Agenda
for
58th PCC meeting

EASTERN REGIONAL POWER COMMITTEE

AGENDA FOR 58TH PROTECTION SUB-COMMITTEE MEETING TO BE HELD AT ERPC, KOLKATA ON 29.08.2017 (TUESDAY) AT 11:00 HOURS

ITEM NO. B.4: Disturbance at 220 kV Lalmatia S/s on 15-07-17 at 09:40 hrs & 13:54 hrs

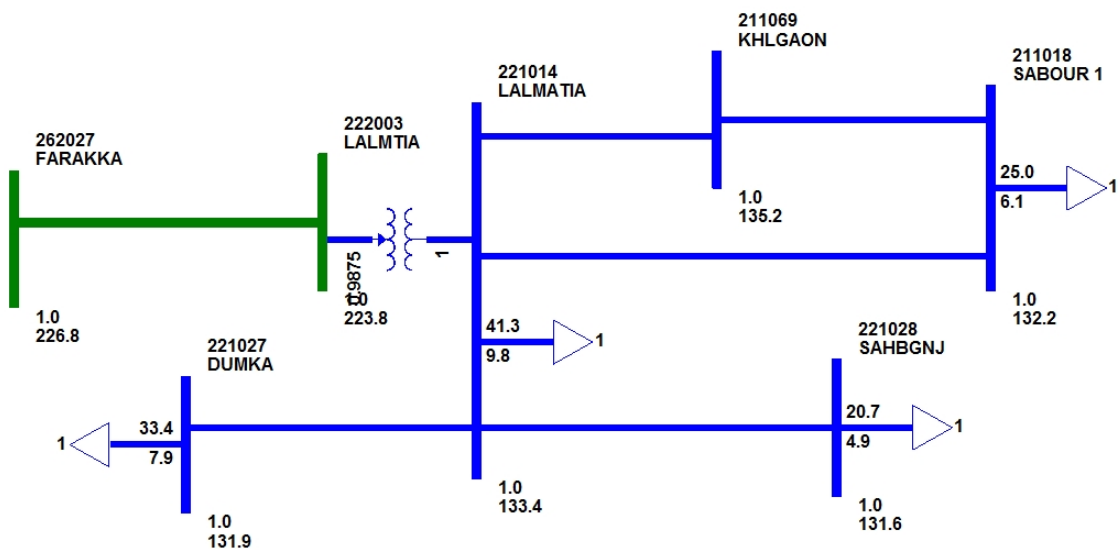
At 09.40hrs 132kv Kahalgaon(BSTPCL) –Lalmatia and 132kv Kahalgaon(NTPC) –lalmatia tripped due to E/F relay causing load loss of 22 MW at Sahebgunj. No recording has been observed in Micom relay.

132 kV Kahalgaon(BSPTCL) - Lalmatia S/C & 132 kV Kahalgaon(NTPC) - Lalmatia S/C tripped again at 13:54 hrs on E/F.

ITEM NO. C.1: Disturbance at 220 kV Lalmatia S/s(JUSNL) on 21-05-17 at 16:39 hrs.

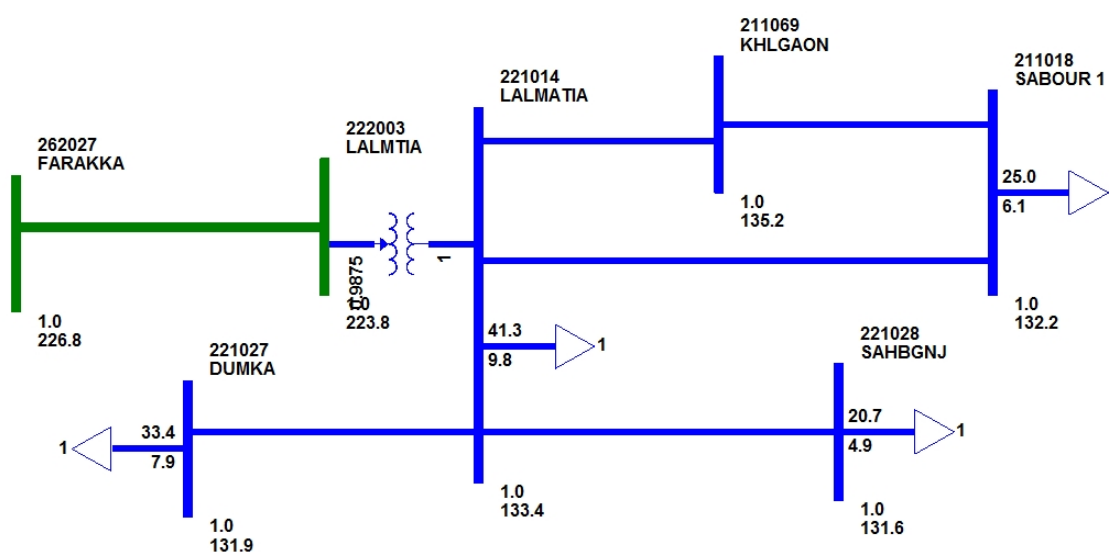
At 16:39 hrs 220 kV Farakka Lalmatia S/C line tripped from Farakka end on O/C E/F protection F/C 4.68 kA in B phase at Farakka.

132 KV Kahalgaon(BSPTCL) - Lalmatia S/C & 132 KV Kahalgaon(NTPC)-Lalmatia S/C were also tripped resulting total loss of power supply at Lalmatia & Sahebgunj. Load at Dumka got survived as it was radially fed from Maithon.

In 56th PCC, NTPC informed that 220kV Farakka-Lalmatia line tripped from Farakka end on B-N fault, the fault distance was 59 km. 132 KV Lalmatia- Kahalgaon line didn't trip from Kahalgaon end. However DR recorded in relay of this line indicates that aforesaid line tripped at Lalmatia end.

PCC advised NTPC to collect tripping details of 220kV Farakka-Lalmatia line at Lalmatia end and submit to ERLDC and ERPC.
